# Access Compliance Report

## Public Rights-of-Way

### (Pedestrian Signals)

Intersection ID: N/A	Main Street:	Cross Street: N/A	Location: N/A
ADA ID: C46E75836A34	Signal Type: One Push Button-Non APS	Overall Compliance: No	Severity Score: BTN 1: N/A BTN 2: N/A No BTN: N/A
Codes/Mitigation Info/Possible Solution		Field Measurements/Component Compliance

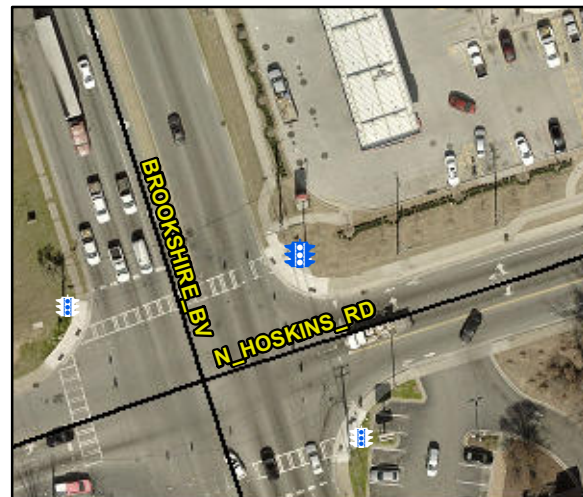
Surveyor Notes: TX HT 5/16

PROW/ADA: R410.6, TMUTCD 4e.08, R406.2

Possible Solutions: Replace Signal Push Button With APS Button on New Post. Remove & Replace Sign.
